**Snohomish County  
Planning and Development Services**

**Subject: Point Wells April 2017 Resubmittal and Preliminary Review Comments**

## **Attachment A: Preliminary Review Comments (as of May 5, 2017)**

Figure 1 – Pedestrian Access Problem to Southern Retail Building  
(Adapted from Sheet A-100 [2017])

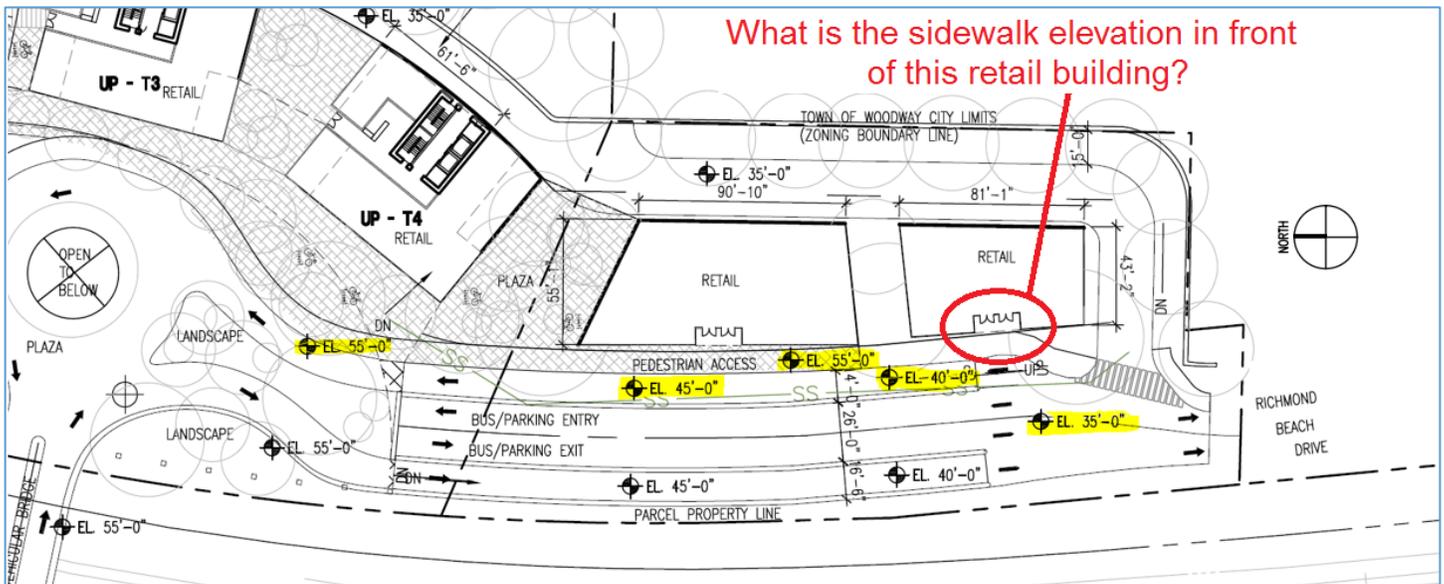
**Site Plan Issue #2:** If a resident wishes to walk to the southern retail building in the Urban Plaza, they will not be able to access the building entrance. As shown on Figure 1, below, the Plaza floor elevation is 55', including the elevation in front of the north retail building. The elevation at Richmond Beach Drive is 35'. The sidewalk will need to ramp up from Richmond Beach Drive to the Plaza Level. Because the south retail building sits adjacent to this ramping sidewalk, there is no way to enter the building directly from the sidewalk and no elevator entry to the building either.

Since the site plan does not provide access to the south retail building, this building cannot count as a service that would help intercept trips that would otherwise go offsite. Accordingly, the 38% internal capture rate would need downward revision. Additional issues<sup>1</sup> with the design of the Urban Plaza would make it impossible for us to recommend approval of this plan with a condition for a simple correction. Therefore, in a recommendation to the Hearing Examiner, PDS could not be supportive of the site plan or traffic assumptions as provided by the applicant.

Figure 2 – Central Village Area Plan with Elevators and Stairwells Highlighted (Adapted from Sheet A-102 [2017])

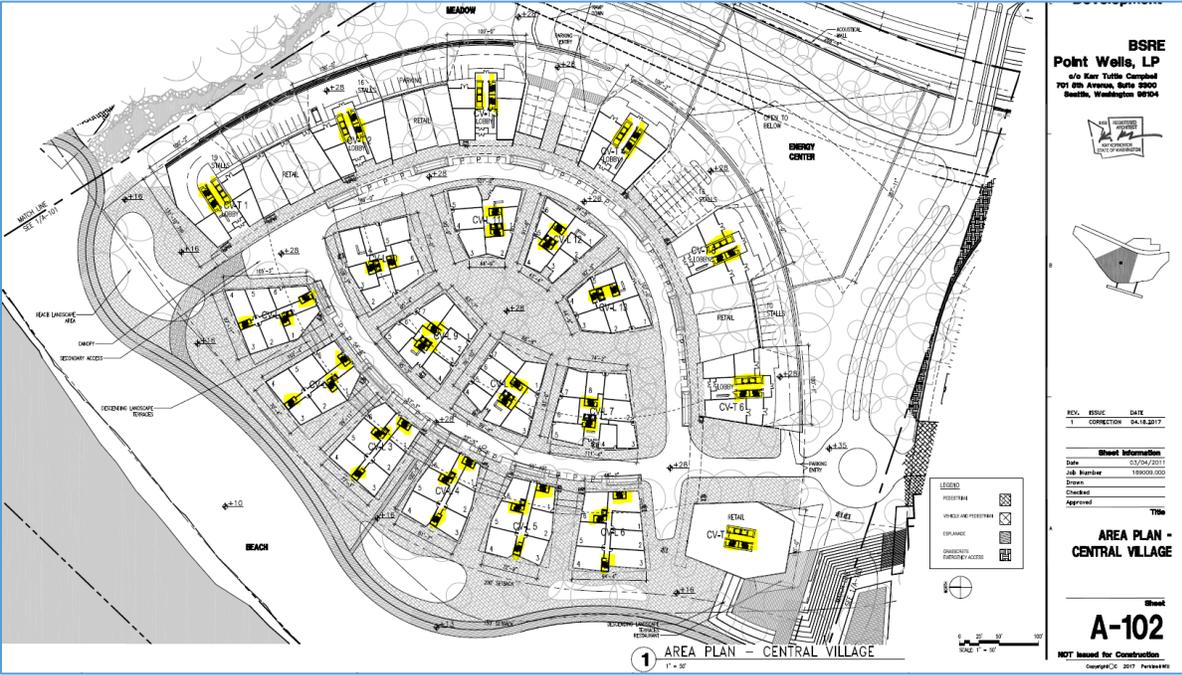
**Site Plan Issue #5:** There are additional problems with parking involving SCC 30.26.020 [2007]. Figure 2 highlights the locations of stairwells and elevators in the 20 buildings of the Central Village (see below). All 20 buildings are on top of a single garage.

Walking access to buildings CV-L3 and CV-L4 is more than 300 feet from the nearest tower elevator. While Sheets A-053 [2017] (not depicted here) and A-102 [2017] (Figure 2) show these buildings as having elevators, the location of elevators depicted on these sheets would include areas on Sheet A-054 (Figure 3) that are taken up by parking, the exterior wall of the garage, and underground areas outside of the garage. Therefore, we can only assume that the elevators go from ground level to the upper floors of these two buildings and that the buildings have no access to the garage.

Figure 3 – Central Village Parking Plan with Elevators and Stairs Highlighted and Approximate Location of Missing Access Points (Adapted from Sheet A-054 [2017])

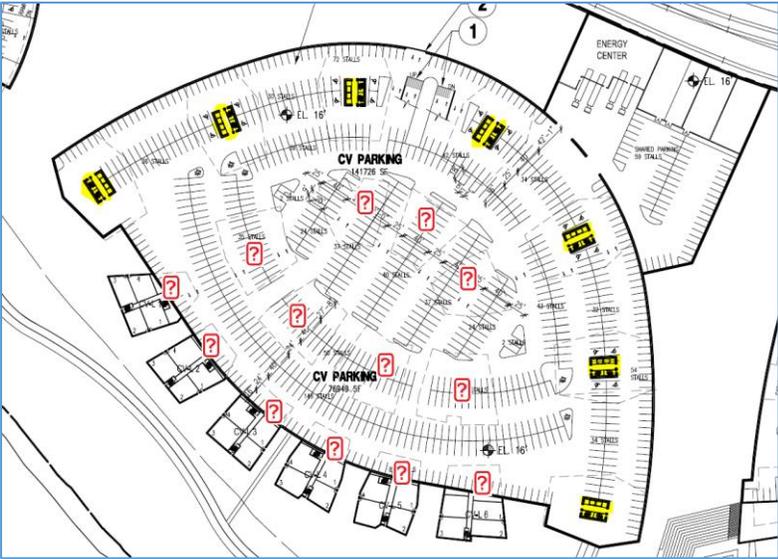
The seven tower buildings each have elevators and stairwells accessing the garage, yet none of the 13 low-rise buildings have direct garage access, see Figure 3, below. From the garage, residents of the low-rise building must take an elevator up to the ground floor of a tower building and then walk at the surface level to reach their own building.

A similar assumption applies to all of the low-rise elevators in the Central Village—they can only be above ground elevators because if these buildings were to connect down into the garage, the layout of parking and drive aisles would need complete redesign. The boxes with question marks in Figure 3 illustrate this problem. Each box represents the approximate area that providing access to the building above would be require from the garage below. Providing this direct access would impact your ability to maintain the number of required parking stalls.

Figure 4 – Stream and Wetland Buffer Impacts of Second Access Road  
(Adapted from Sheet C-200 [2017])

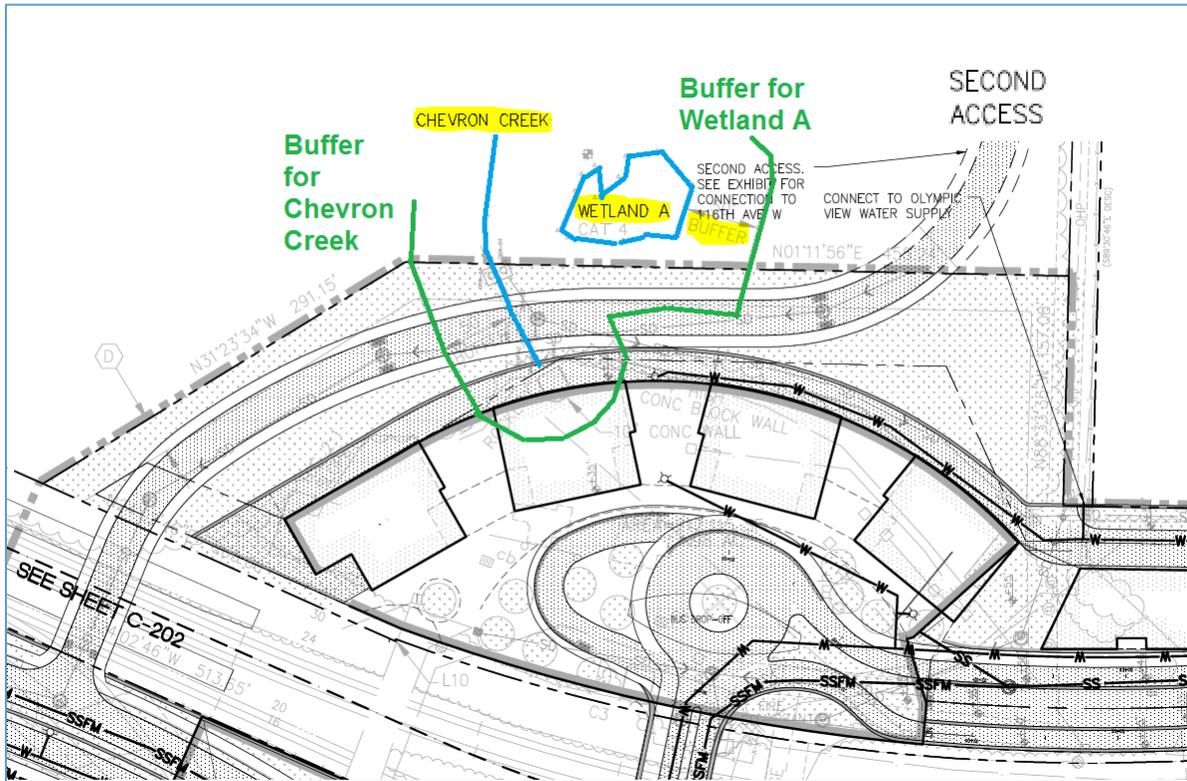
**Site Plan Issue #7:** A second access road appears on the revised site plan. This responds to, but may not adequately alleviate a major concern with the 2011 application, i.e. two adequate fire apparatus access roads (aka fire lanes) are required. However, the location of the second access creates at least one new problem: consistency with critical areas requirements. As shown on Figure 4, next page, the second access road would cross Chevron Creek and go through part of the buffer of a sloping wetland. Shown elsewhere, but not in Figure 4, these features are also in the landslide hazard area.

With proper mitigation and engineering, it is possible that this second access road could be acceptable. However, the request for Innovative Development Design (relief from standard critical area requirements) in the revised submittal does not adequately address these impacts. The Critical Areas Report<sup>3</sup> and Targeted Drainage Report – both updated with the revised submittal to address other issues – both also fail in addressing issues with the second access road. There have been no updates to the Geotechnical Engineering Study since before the 2011 application. This report must address the second access road.<sup>4</sup>

Figure 5 – Landslide Hazard Areas Highlighted on the April 2017 Resubmittal

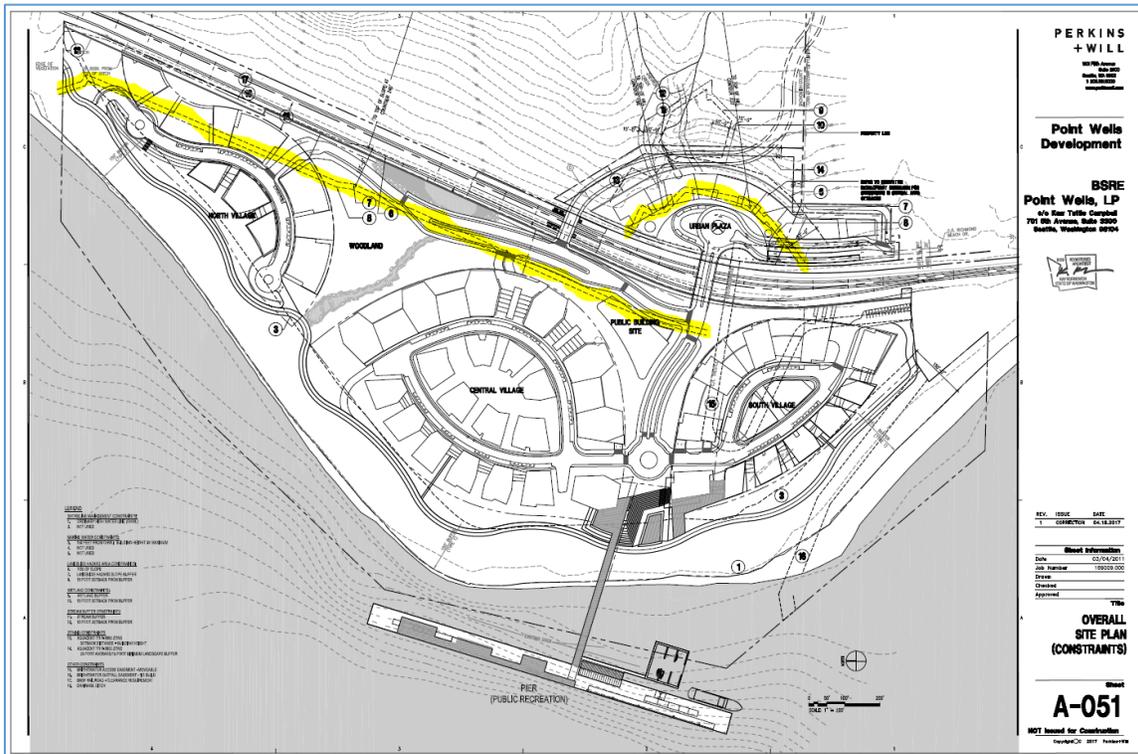
**Site Plan Issue #8:** The April 17, 2017 resubmittal improves on the depiction of the landslide hazard area as shown in the 2011 applications, but the new depiction is still inadequate. It adds a landslide hazard area at the Central and North Villages and does a better job of depicting the area on the Urban Plaza. Figure 5, next page, highlights these landslide hazard areas on the resubmittal. However, these lines must connect as they do on Figure 6, next page, which I emailed to you and others on your team on September 19, 2016. Note that Figure 6 was a comment on the 2011 version of the application.
